Fitting the ACC ON (pink) wire on 632000 and 632001

On new technology beep and park kits 1 (632000) and 2 (632001) the wiring has changed where an additional wire has been added.

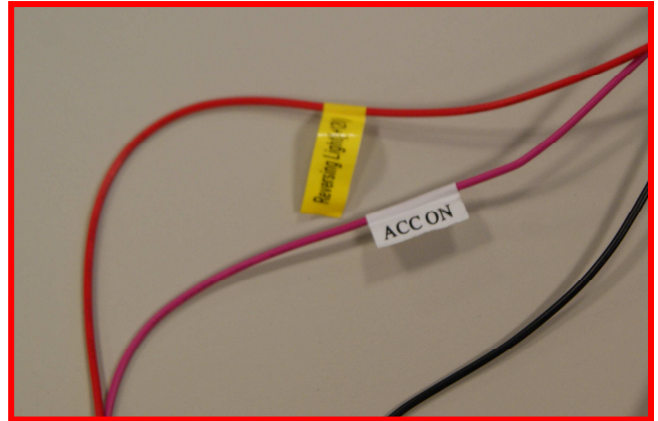
This is to reduce false alarming from the parking sensor on modern vehicles fitted with canbus and where vehicles have a bulb warning feature. The original technology kits had an earth wire (black) and a power/switching wire (red) which connected to the reversing light

New technology kits have a separate wire for the power which is coloured pink and labelled 'ACC ON'.

The pink wire needs to be connected to a switch able 12V supply that is powered once the ignition key is rotated to its first position.

IF THE ACC ON (PINK) WIRE IS NOT CONNECTED THE REVERSING KIT WILL NOT POWER ON!
